1 Comment (clause 33.3.3.12 #251 page 130 line 24)

2 The following changes are required in the dual-signature PD variable list in clause
3 33.3.3.12 and in the dual-signature Type 3 and 4 PD state machines Figure 33-33
4 and Figure 33-34:

1 Suggested Remedy –Option A

1 Suggested Remedy –Option B

Make the following changes on page 135 on Figure 33-33—Type 3 and Type 4 dual-signature PD state diagram for Mode A.

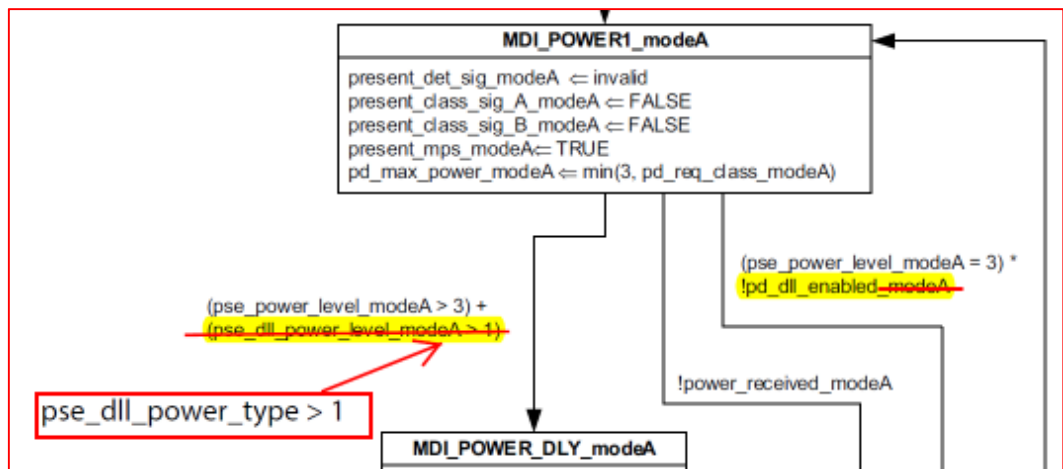
- 5 1. The exits from DLL_ENABLE in Figure 33-33 page 136 and Figure-34 page 138
6 should be update according to the exits in Figure 33-32 page 129 with the
7 prefix `_modeA` and `modeB`.
- 8 2. There is no need for `DLL_ENABLE_modeA/B` due to the fact that if DLL is
9 enabled, it is done for all powered pairs.
- 10 3. There is also no need for `pd_dll_enable_modeA` and `pd_dll_enable_modeB`
11 due to the fact that if DLL is enabled, it is done for all powered pairs.
- 12 4. In figure 33-33, `DO_CLASS_EVENT5` and `DO_MARK_EVENT4` is missing the
13 suffix "`_modeA`".
- 14 5. In figure 33-34, `DO_CLASS_EVENT5` and `DO_MARK_EVENT4` is missing the
15 suffix "`_modeB`".
- 16 6. To verify that all changes will be in sync with Figure 33-50.

Figure 33-33—Type 3 and Type 4 dual-signature PD state diagram for Mode Y

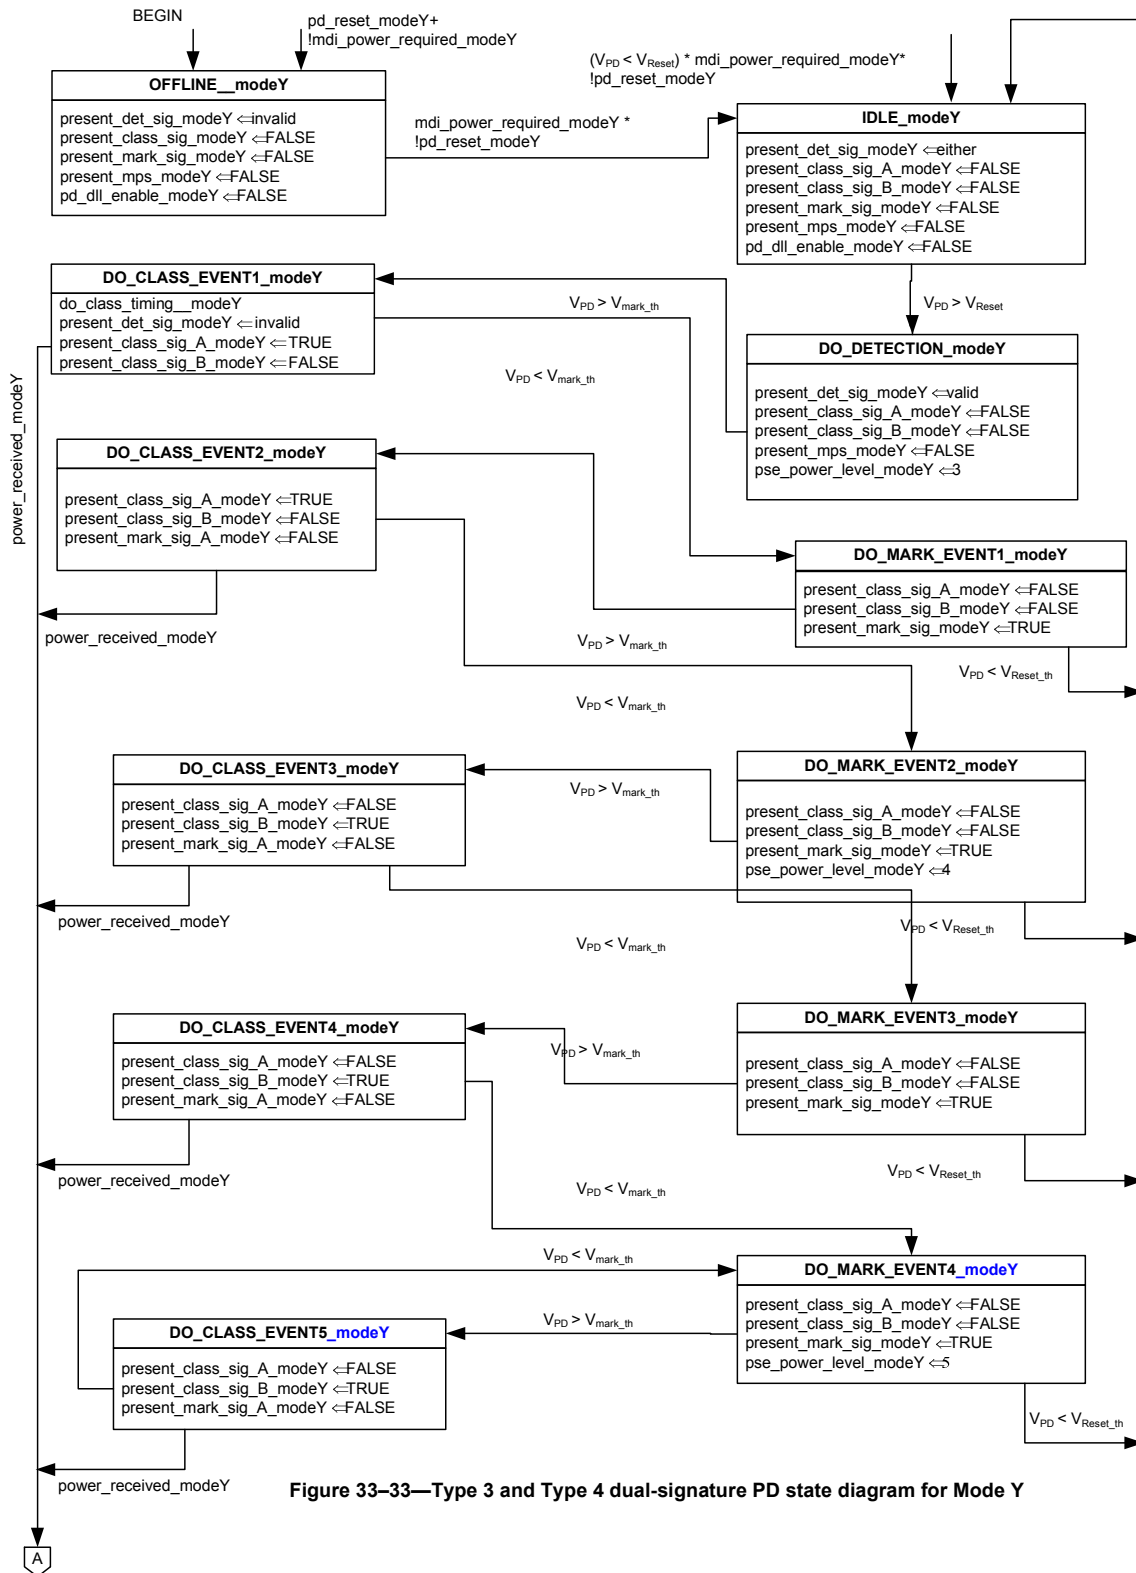
- 19
20 7. Consider to further simplifying the whole dual-signature state machine and
21 its constant, variable, timers and functions starting at page 129 up to page
22 138 by doing the following actions:

23 All constants, variables, timers and functions that ends with the suffix `_modeA` i.e.
24 `parameter_name_modeA` (e.g. `pd_req_class_modeA`) will be change to
25 `parameter_nameY` where the suffix "`Y`" will be "`A`" or "`B`".

- 26 a) All constants, variables, timers and functions that ends with the suffix
27 `_modeB` will be deleted.
- 28 b) Figure 33-33 will be updated with the new suffix "`Y`".
- 29 c) Figure 33-34 will be deleted.

1. Change the title of figure 33-33 on page 135 as follows:

“Figure 33–33—Type 3 and Type 4 dual-signature PD state diagram for ~~mode X~~mode Y”

3. Make the following changes in Figure 33-33 on page 135.

DO_CLASS_EVENT5 and DO_MARK_EVENT4 is missing the suffix “_modeY”.

4. Make the following changes in Figure 33-33 on both pages 135 and 136:

Replace all parameters with the suffix “modeA” with “~~mode X~~mode Y”
